S E R V I C E N O T E

J2301B Internet Advisor

Possible fire hazard

Note Drawing shown with the rear panel removed.

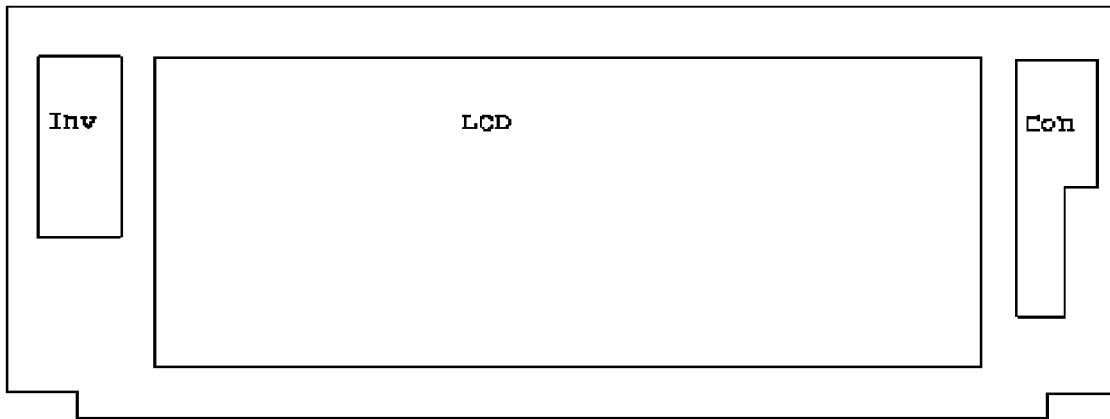
The 0950-2937 Display Board Inverter Assembly installed into the J2301B display does not meet Agilent's Fire Retardant standards and should be replaced. Inverter boards 0950-2937 marked with LOT 56 on the transformer in instruments with the serial number prefixes should have this modification to prevent instrument damage.

1. Remove the back panel from the display by removing 6 painted screws.
2. Locate 0950-2937 (note drawing marker “Inv”), remove 2 screws and cables from the board and remove the inverter board from the display assembly.
3. Replace the board with 0950-2937 with different LOT number.
